Bulletin No.: 03-07-30-011E

Service Bulletin

Subject: Allison Transmission Delayed Engagement, Cold Hesitation, Malfunction Indicator Lamp (MIL) Illuminated, DTCs P0701, P1709, P1711, P1713, P0841, P0843, P0847, P0870, P0872, or P0875 (Replace Torque Converter Relief Spring, Transmission Fluid Indicator and Lube Regulator Spring in Front Support)

Models: 2001–2003 Chevrolet Silverado 2500/3500 Series
 2001–2003 GMC Sierra 2500/3500 Series
 with Allison® 1000 Series Automatic Transmission (RPO M74)
 Built Prior to Indianapolis Plant Serial Number 6310234829, Baltimore Plant
 Serial Number 6320154492 and Remanufactured Transmission Serial
 Number 9620011913

1213450

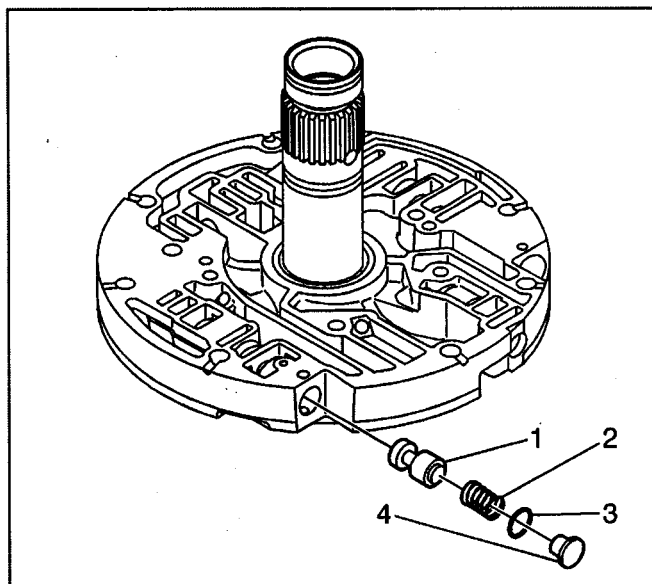
8. With the ground sleeve facing up and the support assembly turned so the area without visible oil passages is on the top right, a notch should be seen at the upper left portion of the support assembly. With the aid of the J 43773 (2), compress the lube regulator spring to enable removal of the retaining pin (1). The following items are to be removed.

1213545

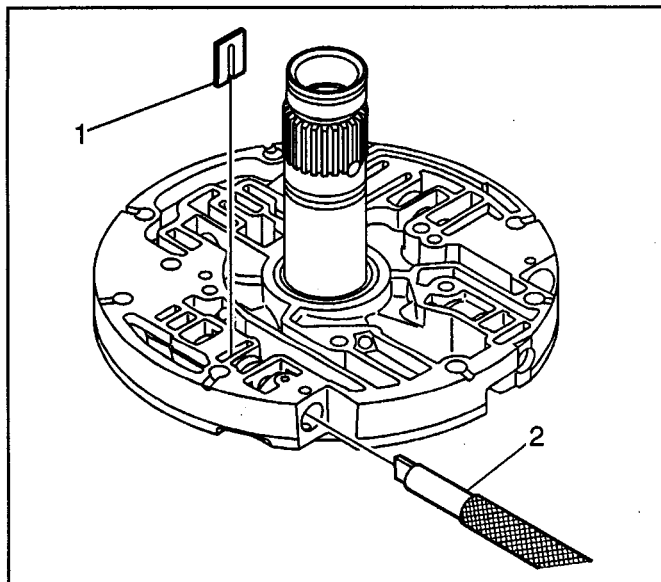
- The retaining pin
- The stop (4) with O-ring seal (3) (remove and discard the O-ring seal)
- A short spring (2)
- The lube regulator valve (1)

1213614

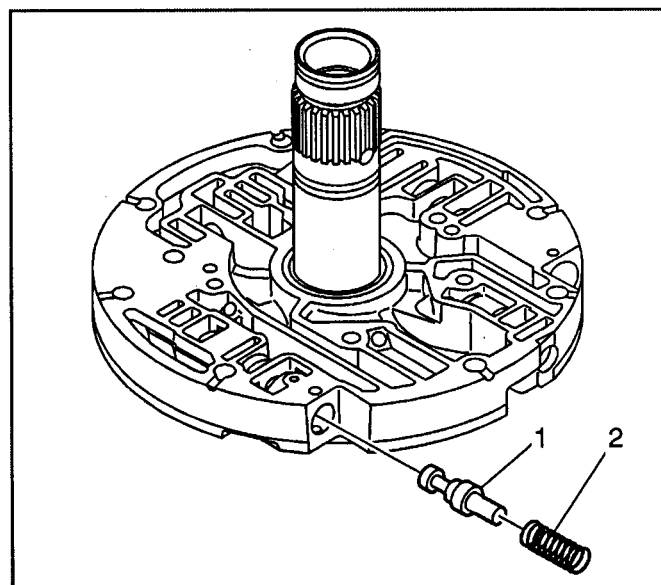
9. Insert the J 43773 (2) into the bore you just removed the above components from. Compress the converter relief valve spring enough to remove the "U" shaped retaining clip (1) and remove the clip. Then remove the following items.

- The converter relief spring (2)
- The converter relief valve (1)

1213653

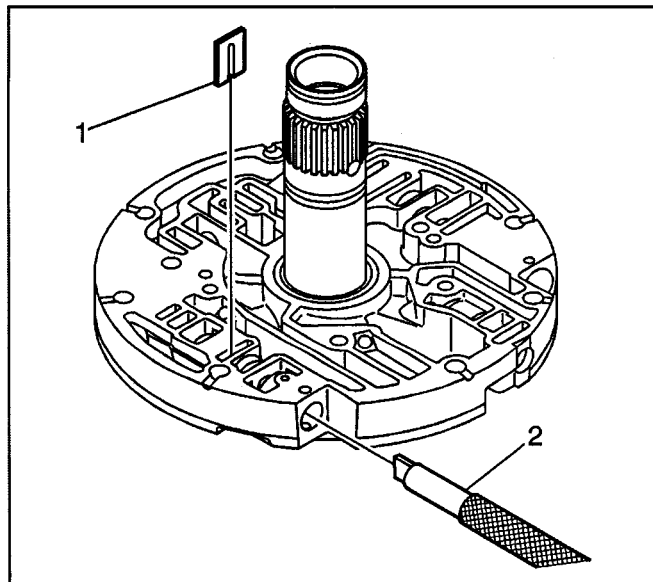
10. Position the support assembly so that the converter relief valve/lube regulator bore is facing upward. Then install the following components.
- The converter relief valve (1) (big end first, the small end fits into the converter relief spring)
 - The converter relief spring (2) (Natural steel, no color, free length 44.85 mm (1.766 in))

1213614

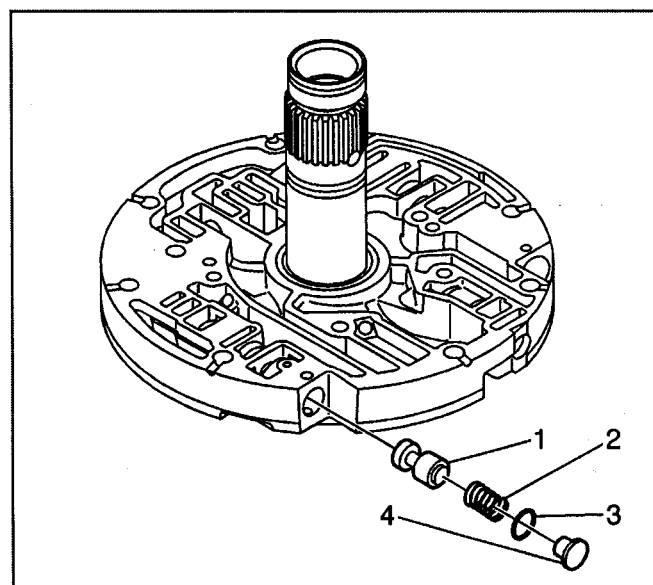
11. Use J 43773 tool (2) to compress the spring. Install the retaining clip (1). Ensure that the clip is below the surface of the support.
12. Remove the J 43773 tool.
